COUNCIL ASSESSMENT REPORT

Panel Reference	PPSSNH-377
DA Number	DA66/23
LGA	North Sydney Council
Proposed Development	Partial demolition of the existing heritage building, construction of a 13 storey mixed use building comprising ground floor and first floor commercial tenancies, 61 residential apartments, basement parking, public domain works and landscaping.
Street Address	286 – 294 Pacific Highway, Crows Nest Lot 1 DP 1279891
Applicant/Owner	Applicant – Eastinwest Pty Ltd and Visionvest Pty Ltd. Owners – Eastinwest Pty Ltd and Visionvest Pty Ltd.
Date of DA lodgement	8 March 2023
Total number of Submissions Number of Unique Objections	Eighteen (18) submissions received.
Recommendation	Refusal
Regional Development Criteria Schedule 6 of the SEPP (Planning Systems) 2021	Regional Development is defined in Schedule 6 of State Environmental Planning Policy (Planning Systems) 2021 Development with a capital investment value (CIV) over \$30 million is classified as “Regional”. The CIV of this development as outlined in the application is \$50,030,000 excluding GST.

Figure 13: LEP Height plane drawing which illustrates the components which are above the height control as viewed from Pacific Highway (Source: Fuse Architects).

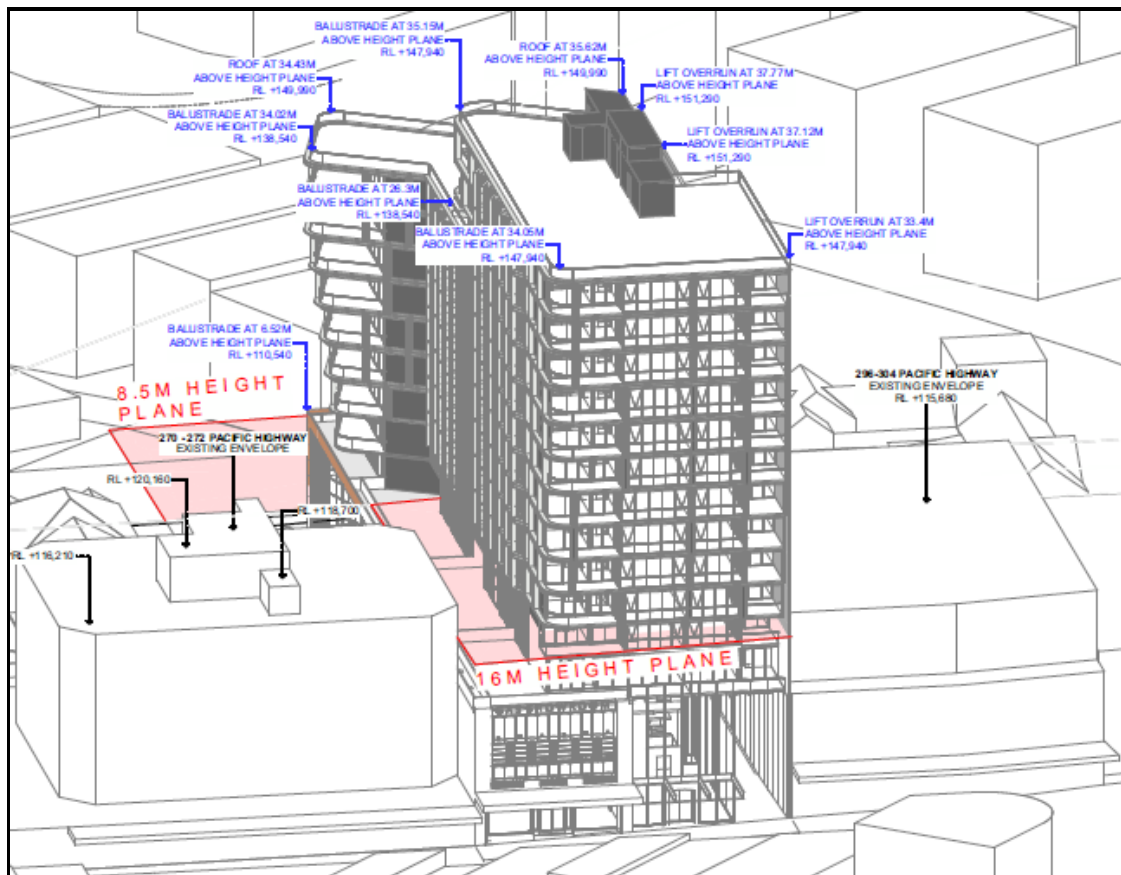
97. The proposed development seeks a variation to the development standard relating to height (Clause 4.3). The NSLEP identifies a maximum height control of 16m of the area of the site zoned MU1 Mixed Use and 8.5m for the area of the site zoned R2 Low Density Residential. The building is proposed to be 34.43m in height in the R2 zoned land which exceeds the maximum building height by 25.93m, a variation of 405.1% to the development standard. The building is proposed to be 53.77m in height in the MU1 zoned land, which exceeds the maximum building height by 37.77m, a variation of 236.1% to the development standard.
